[Docket No. 98-NM-323-AD]

Airworthiness Directives; Boeing Model 757-200, -200PF, and -200CB Series Airplanes Powered by Rolls-Royce RB211-535C/E4/E4B Turbofan Engines

ACTION: Supplemental notice of proposed rulemaking; reopening of comment period.

FIGURE 1

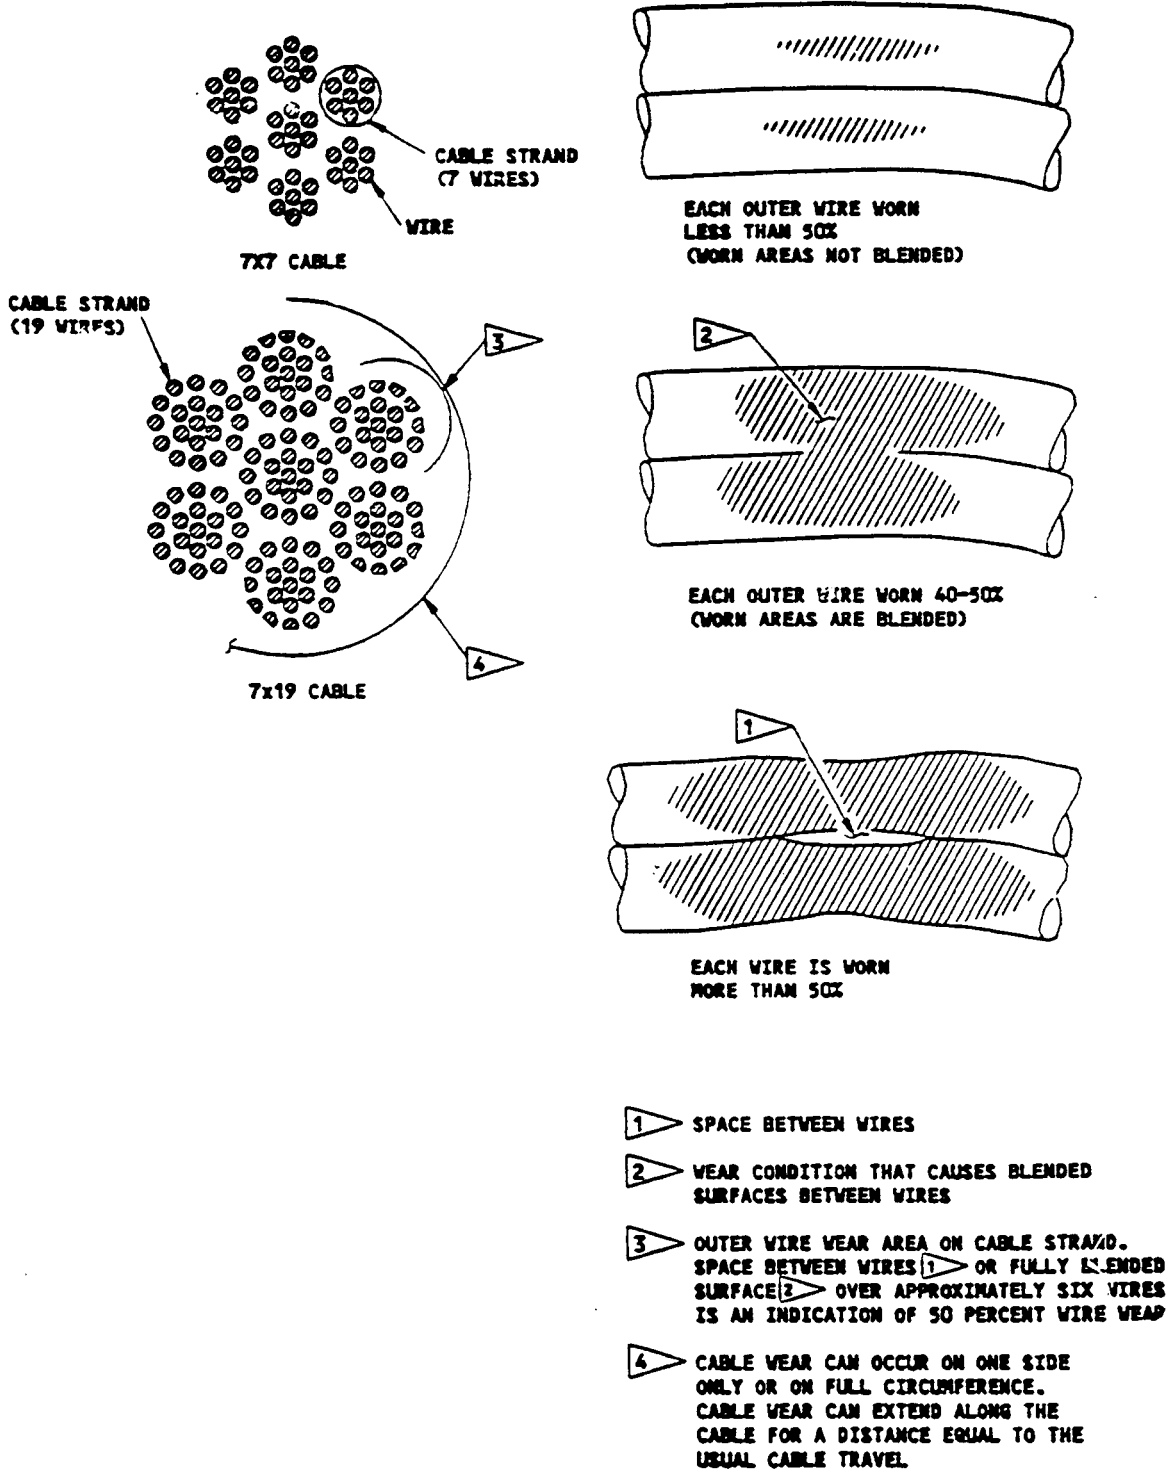
(1) One cable strand had worn wires where one wire cross section is decreased by more than 40 percent (see Figure 1),

B. Perform a detailed visual inspection of the cable runs to detect incorrect routing, kinks in the wire rope, or other damage. Replace the cable assembly if:
